Contract #: 04-0120F4Cty: SF/ALA Rte: 80 PM: 13.2/13.9File #: 69.25B**QUALITY ASSURANCE -- NON-CONFORMANCE REPORT****Location:** Changxing Island, Shanghai, P.R. China**Report No:** NCR-000680**Prime Contractor:** American Bridge/Fluor Enterprises, a JV**Date:** 12-Feb-2010**Submitting Contractor:** Zhenhua Port Machinery Company, Ltd (ZPMC), Changxing Island**NCR #:** ZPMC-0647**Type of problem:**

Reference Description: Offset of theoretical alignment of some T-Rib Stiffeners for OBG Segment 7BE to 7CE

| Subject: | NCR No. ZPMC-0647 | Document No: | 05.03.06-000637 |

Contract #: 04-0120F4Cty: SF/ALA Rte: 80 PM: 13.2/13.9File #: xx.25A**QUALITY ASSURANCE -- NON-CONFORMANCE RESOLUTION****Location:** Changxing Island, Shanghai, P.R. China**Report No:** NCS-000682**Prime Contractor:** American Bridge/Fluor Enterprises, a JV**Date:** 17-Jul-2010**Submitting Contractor:** Zhenhua Port Machinery Company, Ltd (ZPMC), Changxing Island **NCR #:** ZPMC-0647**Type of problem:**

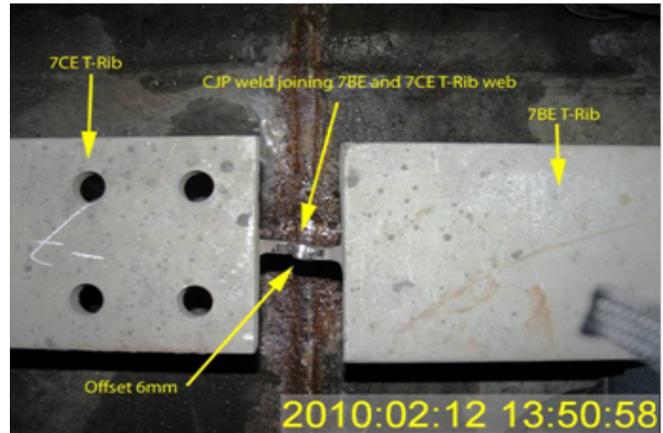
- Offset of theoretical alignment of some T-Rib Stiffener (in Segment 7BE) to T-Rib Stiffener (in Segment 7CE) at welded web joints was found. Locations are listed below.
- The welds are Complete Joint Penetration (CJP) butt welds.
- The maximum out of tolerance offset measurements across the weld per AWS D1.5 2002 is 3mm.
- These offset welded weld joints at the T-rib stiffener webs are listed below:

BP171-001-020, 1st T-Rib, 4mm offset
BP171-001-022, 2nd T-Rib, 7mm offset
BP171-001-024, 3rd T-Rib, 6mm offset
BP171-001-028, 5th T-Rib, 5mm offset
BP171-001-030, 6th T-Rib, 4mm offset
BP117-001-022, 14th T-Rib, 4mm offset
BP117-001-030, 18th T-Rib, 4mm offset

SP365-001-044, 1st T-Rib, 5mm offset
SP365-001-048, 2nd T-Rib, 4mm offset
SP365-001-052, 3rd T-Rib, 4mm offset

SP365-001-056, 5th T-Rib, 5mm offset
SP311-001-063, 13th T-Rib, 6mm offset
SP311-001-061, 14th T-Rib, 5mm offset
SP311-001-059, 15th T-Rib, 6mm offset
SP311-001-057, 16th T-Rib, 5mm offset

AWS D1.5 (02) Section 3.3.3; "Parts to be joined by groove welds shall be carefully aligned. Where the parts are effectively restrained against bending due to eccentricity in alignment, the offset from theoretical alignment shall not exceed 10 percent of the thickness of the thinner part joined, but in no case shall be more than 3 mm [1/8 in]."

Reference Resolution: ZPMC is providing the dimensional verification records which show that T and I rib splice offset values are within tolerance.

This proposed resolution is acceptable. The Department concurs that Non-Conformance ZPMC-0647 is closed.

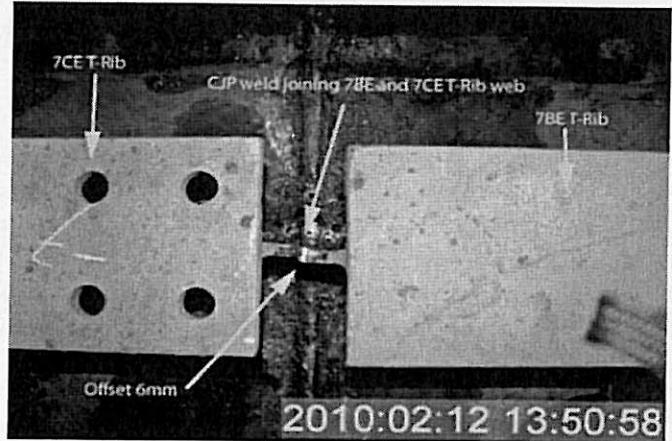
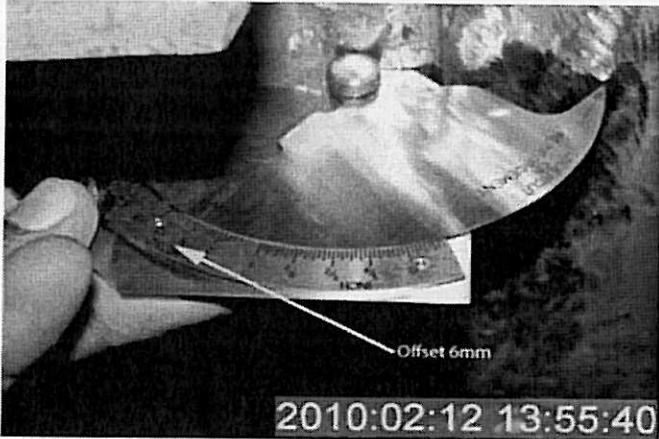
- Offset of theoretical alignment of some T-Rib Stiffener (in Segment 7BE) to T-Rib Stiffener (in Segment 7CE) at welded web joints was found. Locations are listed below.
- The welds are Complete Joint Penetration (CJP) butt welds.
- The maximum out of tolerance offset measurements across the weld per AWS D1.5 2002 is 3mm.
- These offset welded weld joints at the T-rib stiffener webs are listed below:

BP171-001-020, 1st T-Rib, 4mm offset
 BP171-001-022, 2nd T-Rib, 7mm offset
 BP171-001-024, 3rd T-Rib, 6mm offset
 BP171-001-028, 5th T-Rib, 5mm offset
 BP171-001-030, 6th T-Rib, 4mm offset
 BP117-001-022, 14th T-Rib, 4mm offset
 BP117-001-030, 18th T-Rib, 4mm offset

SP365-001-044, 1st T-Rib, 5mm offset
 SP365-001-048, 2nd T-Rib, 4mm offset
 SP365-001-052, 3rd T-Rib, 4mm offset

SP365-001-056, 5th T-Rib, 5mm offset
SP311-001-063, 13th T-Rib, 6mm offset
SP311-001-061, 14th T-Rib, 5mm offset
SP311-001-059, 15th T-Rib, 6mm offset
SP311-001-057, 16th T-Rib, 5mm offset

AWS D1.5 (02) Section 3.3.3; "Parts to be joined by groove welds shall be carefully aligned. Where the parts are effectively restrained against bending due to eccentricity in alignment, the offset from theoretical alignment shall not exceed 10 percent of the thickness of the thinner part joined, but in no case shall be more than 3 mm [1/8 in]."

The method what inspector utilized was not specified among three parties. ZPMC is providing the dimension check report for 7BE/7CE T & I Ribs splices what shows all the offset are within allowance. This item has been removed from Punchlist by CT's representative. Based on this, ZPMC is request withdrawal of this NCR.

Propose a resolution for the identified non-conformance for BP-171-001-022 with revised procedures to prevent future occurrences according to the response to RFI 1869 dated 02-11-10. The other locations mentioned in this NCR are within the fit for purpose range mentioned in RFI 1869 and no further action is required. A response for the resolution of this issue is expected within 7 days.
